Access Compliance Report

Public Rights-of-Way

Intersection ID: 42646	Main Street: E_4TH_ST	Cross Street: S_TORRENCE_ST	Location: NW
ADA ID: 9AFDAD4ED382	Ramp Type: PerpDiag	Initial Pass/Fail: Fail	Overall Compliance: No
Severity Score: 12.5			
Codes/Mitigation Info/Possible Solution		Field Measurements/Component Compliance

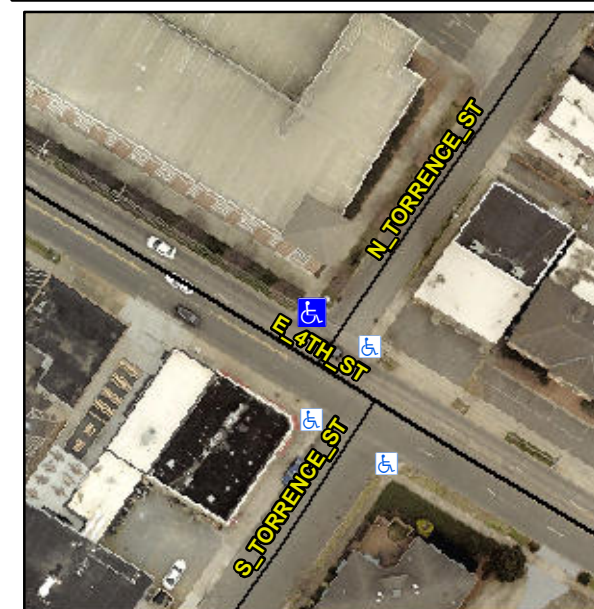
Remove & Replace Curb Ramp With Two New Directional Ramps or Equivalent.

R304.5.3
